Form C-103
Revised March 25, 1999

WELL API NO. 30-015-30446
5. Indicate Type of Lease STATE <input checked="" type="checkbox"/> FEE <input type="checkbox"/>
6. State Oil & Gas Lease No. B8318-128
7. Lease Name or Unit Agreement Name: OXY Chopsticks State
8. Well No. 1
9. Pool name or Wildcat Undesignated Wolfcamp

SUNDRY NOTICES AND REPORTS ON WELLS (DO NOT USE THIS FORM FOR PROPOSALS TO DRILL OR TO DEEPEN OR PLUG BACK TO A DIFFERENT RESERVOIR. USE "APPLICATION FOR PERMIT" (FORM C-101) FOR SUCH PROPOSALS.)	
1. Type of Well: Oil Well <input type="checkbox"/> Gas Well <input checked="" type="checkbox"/> Other	
2. Name of Operator OXY USA WTP Limited Partnership 192463	
3. Address of Operator P.O. Box 50250 Midland, TX 79710-0250	
4. Well Location Unit Letter <u>F</u> : <u>1750</u> feet from the <u>north</u> line and <u>1980</u> feet from the <u>west</u> line Section <u>28</u> Township <u>17S</u> Range <u>27E</u> NMPM County <u>Eddy</u>	
10. Elevation (Show whether DR, RKB, RT, GR, etc.) 3483'

OXY USA WTP LP - Proposed
OXY Chopsticks State #1
API No. 30-015-30446

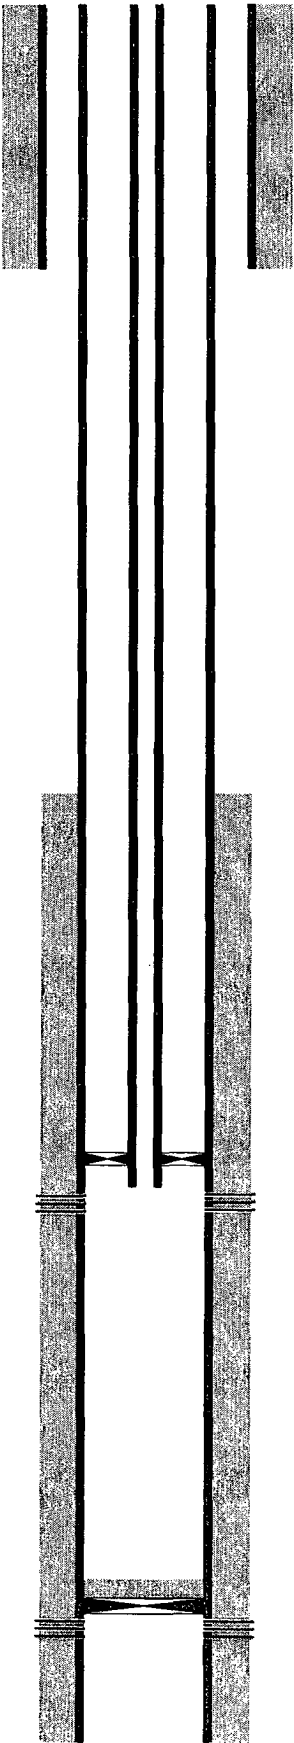
Conditions of approval, if any: Additional plugs as indicated

3000' plug →

5190' plug →

6240' plug →

1. RIH & Set CIBP @ 6780', dump 3sx cmt to 6745' 6242' Plug (25sx)
2. Cut & Pull 4-1/2" csg @ +/- 4600' 5792' Plug (25sx)
3. M&P 35sx cmt @ 4650-4550'-WOC-TAG
4. M&P 45sx cmt @ 3200-3100' 3000' Plug
5. M&P 45sx cmt @ 2300-2200'
6. M&P 45sx cmt @ 1550-1450'-WOC-TAG
7. M&P 40sx cmt @ 500-400'
8. M&P 20sx cmt surface plug 0-60 surface plug - WOC 24 hrs - TAG/Top Off cmt
10# MLF between plugs
